**Planning Commission
Regular Meeting Agenda
Wednesday, November 2, 2022 at 7:00 p.m.**

**City of Lowell, Oregon
Minutes of the Planning Commission Meeting
September 7, 2022**

**Revised Staff Report
Site Plan Review Application
Mixed-Use Development on North Shore LU 2022 02 (Phase 1)
October 26, 2022**

AS-002

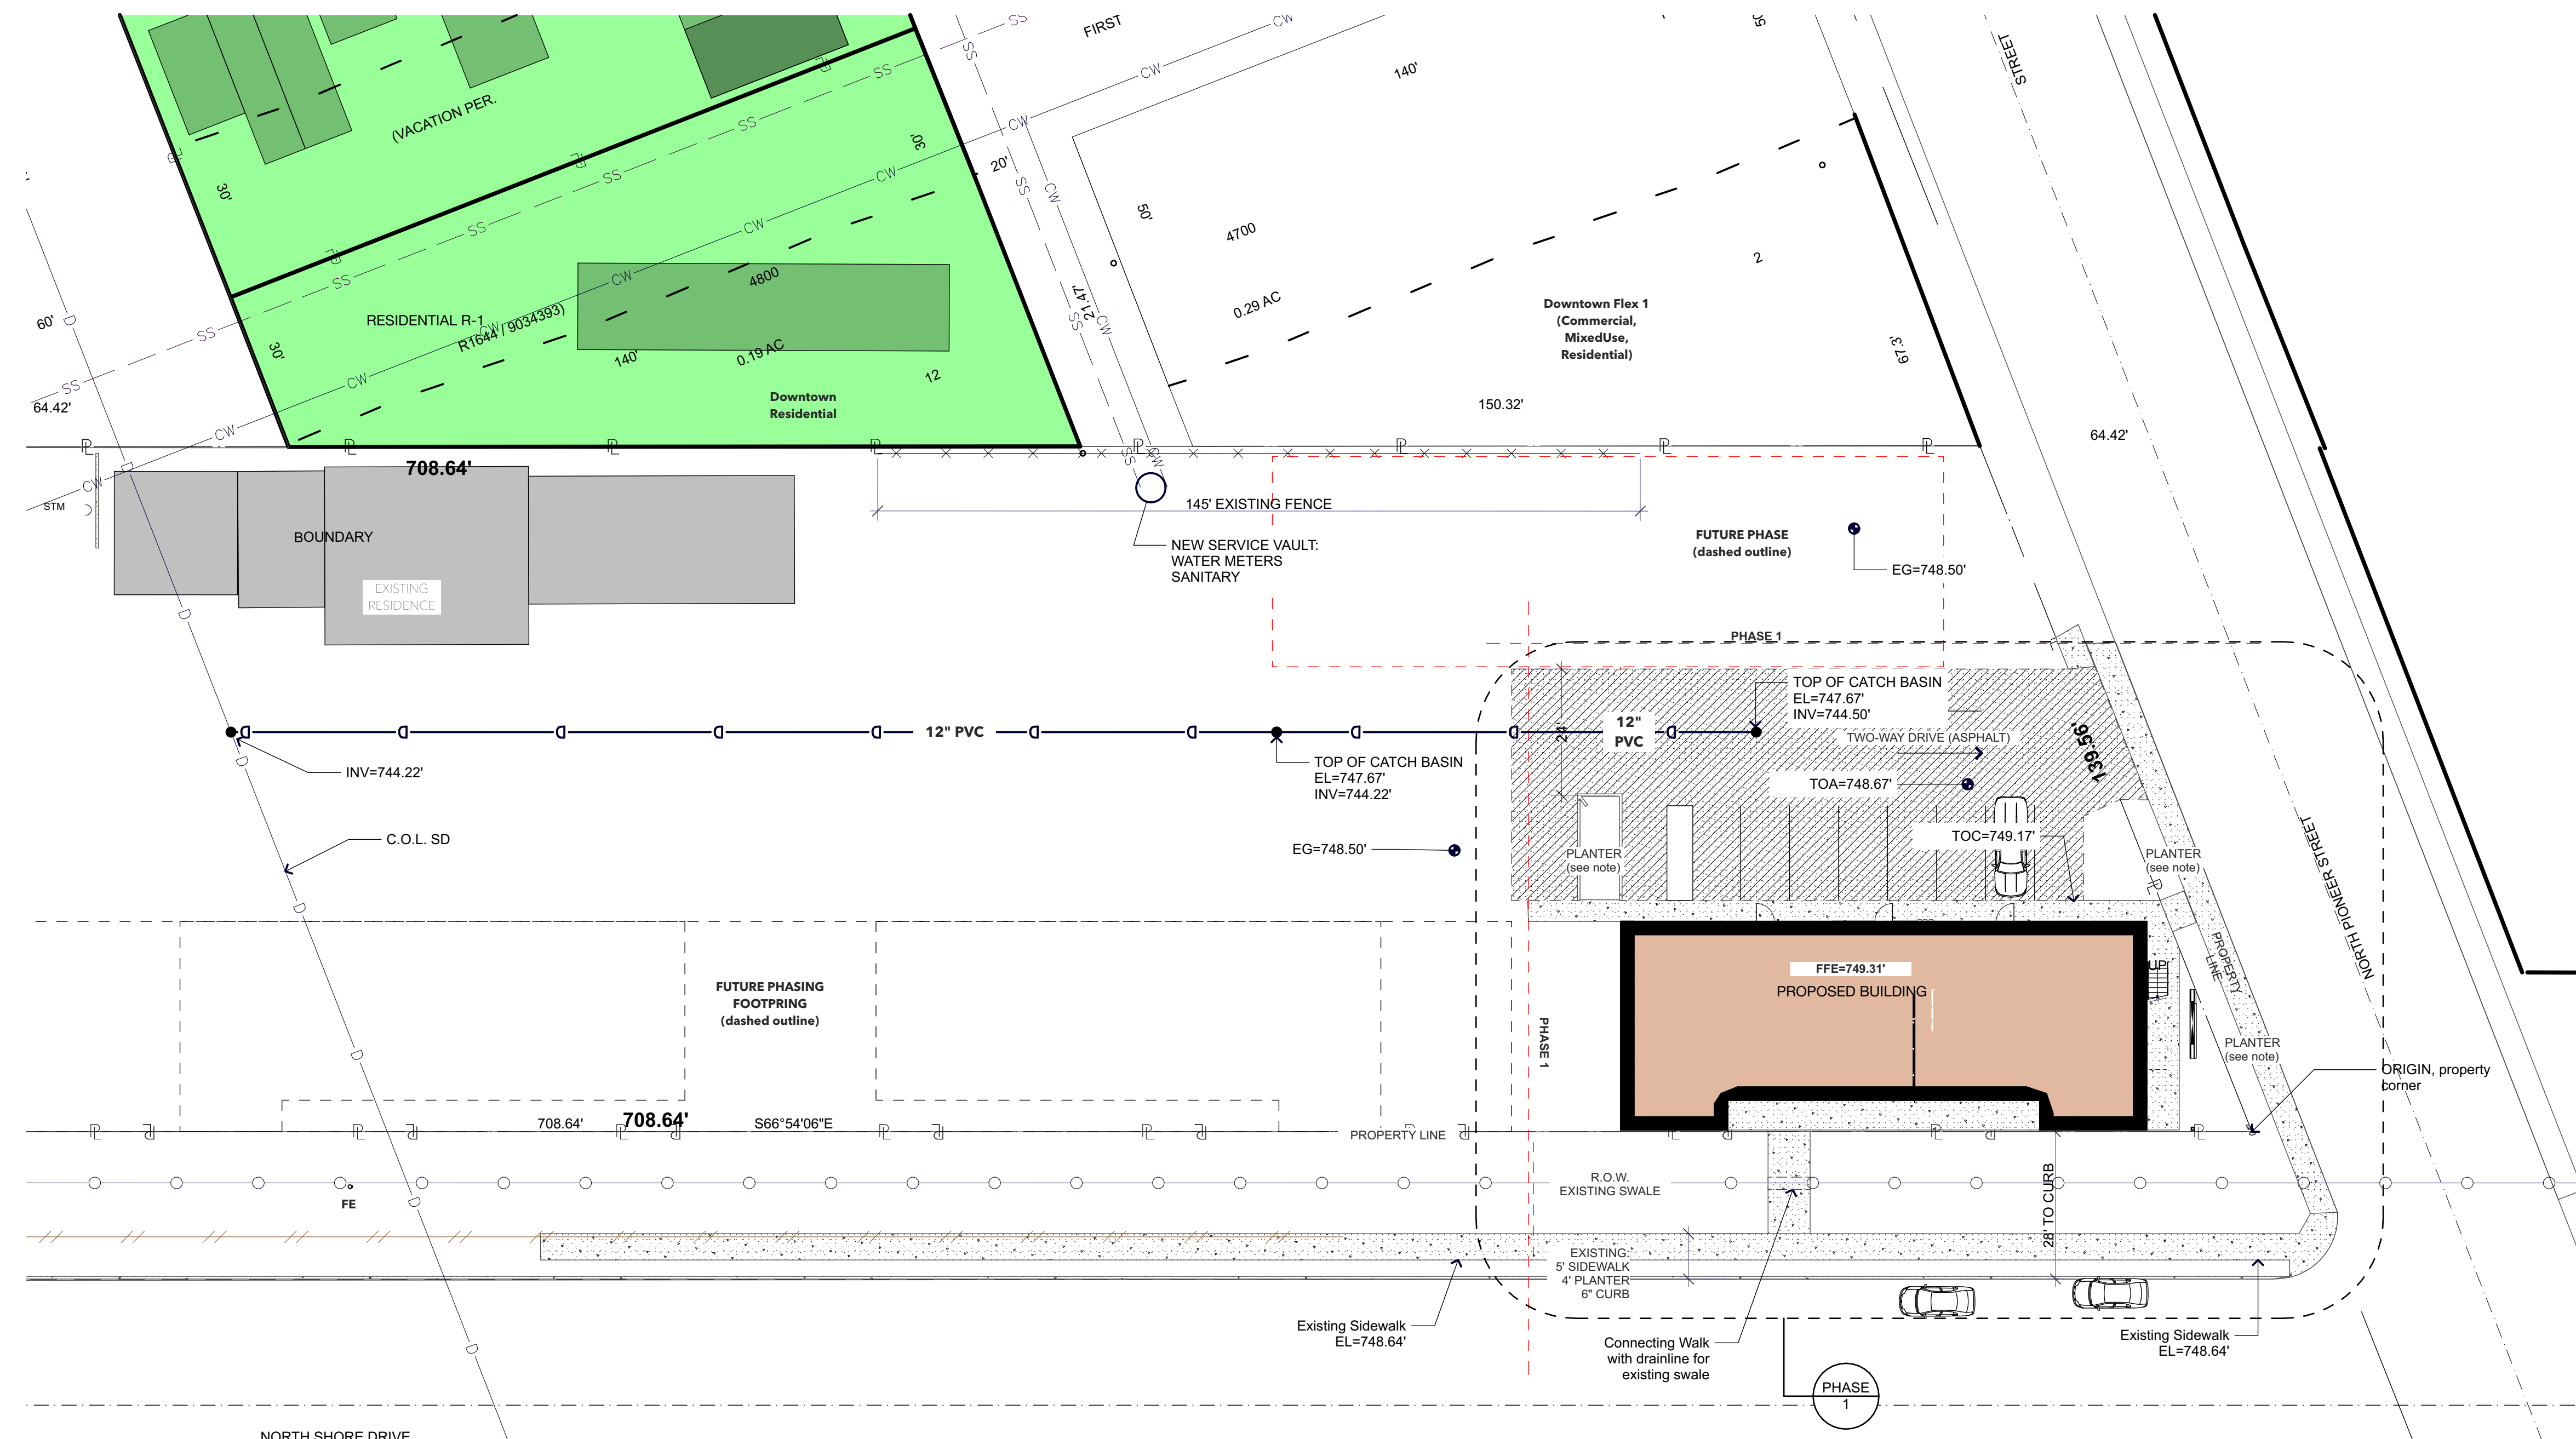
Recommended FINDING for approval: As seen on Sheet AS-002, the development will take access from a curb cut along North Pioneer Street, approximately 70-feet from the southwest corner of the property. The entirety of the proposed buildings and landscape features (including those adjacent to North Shore) are fully contained within the property or right-of-way.

Recommended FINDING for approval: The applicant has submitted a revised preliminary grading plan as seen on Sheet AS-002. The applicant has listed the grading standards on the plan itself. Staff find the preliminary plan submitted is sufficient to establish feasibility that grading standards can be met. Further, staff also cite evidence as to the site's slope characteristics. The site (seen below in Image 5) is relatively flat. The site does not contain any slopes in excess of 15%. Therefore, based on the revised preliminary grading plan and the fact that the site is flat, staff find it's feasible for the applicant to meet the grading standards of Section 9.527 and Ordinance 227, Section 2. A final grading plan can be delegated to the City Engineer for review and approval. This will be a condition of approval.
